febi 40308

to fit:
Audi, VW, Seat and Škoda 1,6 TDI and 2.0 TDI engines with common-rail injection system

Multi-V Belt Kit

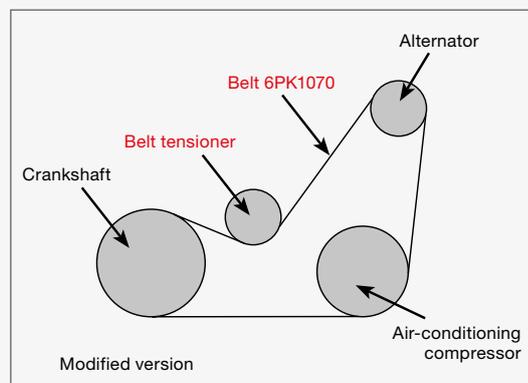
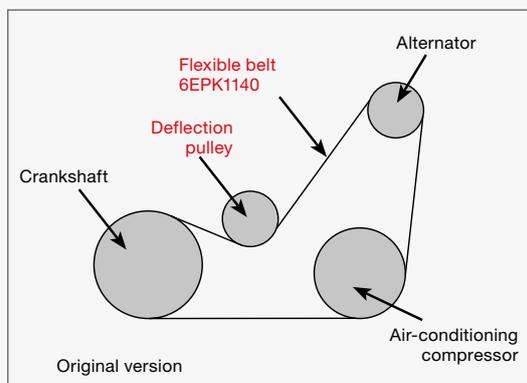
The flexible multi-V belt 6EPK1140 for the engines referred to above is no longer installed and the new belt 6PK1070 cannot be fitted directly.

The original version of the auxiliary drive was powered via the flexible multi-V belt and the deflection pulley (Fig. 1). To improve the running characteristics, vehicle manufacturers have developed a new design for the auxiliary drive.

Instead of a flexible belt and the deflection pulley, the modified version uses a new multi-V belt and a tensioning element (Fig. 2). For this reason, in addition to the components that are available individually, febi also offers a complete multi-V belt kit (febi no. 40308) which also includes the mounting screw as well as the new belt (febi no. 37533) and the belt tensioner (febi no. 27618).
